Proposal for amendments to ECE/TRANS/WP.29/GRSG/2019/30

Annex 3

Figure [#]

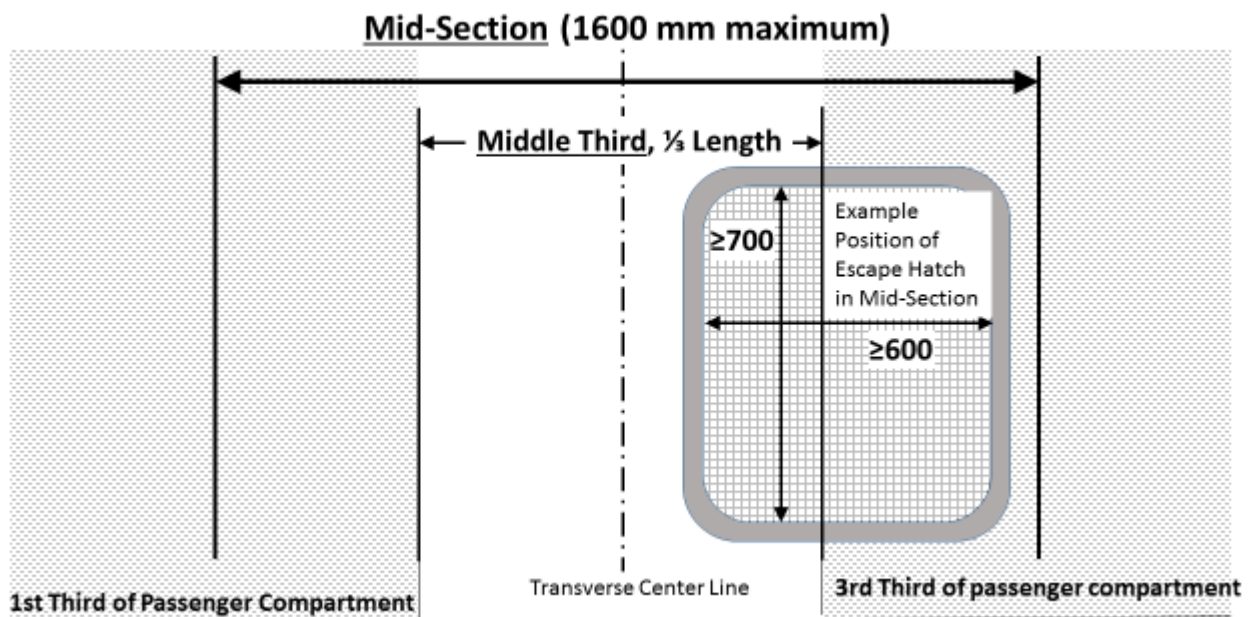
Insert a new Paragraph 7.6.2.9. to read:

“7.6.2.9. For vehicles of classes A and B, required escape hatches shall be positioned as follows:

- (a) If there is only one hatch, it shall be situated in the middle third of the passenger compartment. As an alternative, on vehicles with a very short passenger compartment length, the hatch may be located in the mid-section of this compartment, and this mid-section shall be equally spaced longitudinally each side of the transverse centre line of the passenger compartment, with a length of no greater than [1.6m] as shown in figure [].
- (b) If there are two hatches, they shall be separated by a distance of at least 2 m measured between the nearest edges of the apertures in a line parallel to the longitudinal axis of the vehicle.

Alternative placement of escape hatch for very short passenger compartment length having a middle third smaller than 1600 mm”
